South Texas Project Units 1 & 2

STP Pilot Submittal for Risk-Informed Approach to Resolving GSI-191

STP Responses to Acceptance Review Letter

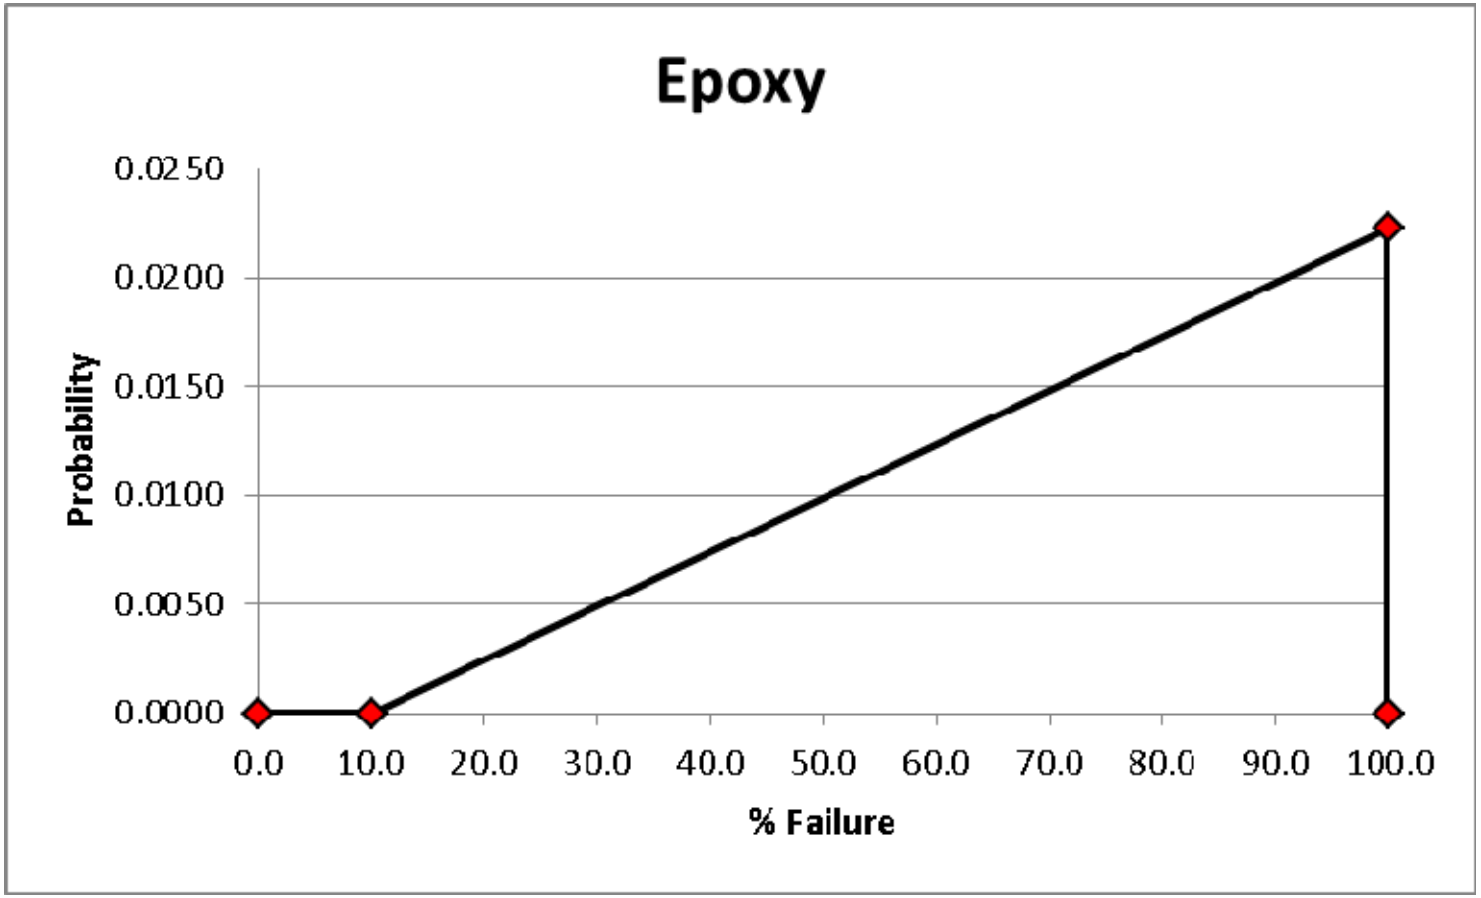
5.a.1) Failure timing, failure amounts, and debris characteristics of unqualified coatings.

- Input parameters used for failure timing, failure amounts, and characteristics of unqualified coatings are provided in Volume 3.
- Description of the method, basis, and assumptions used to develop the unqualified coatings input parameters is provided in a plant-specific unqualified coatings calculation.
- As an example of the detailed information that will be provided in the revised submittal:
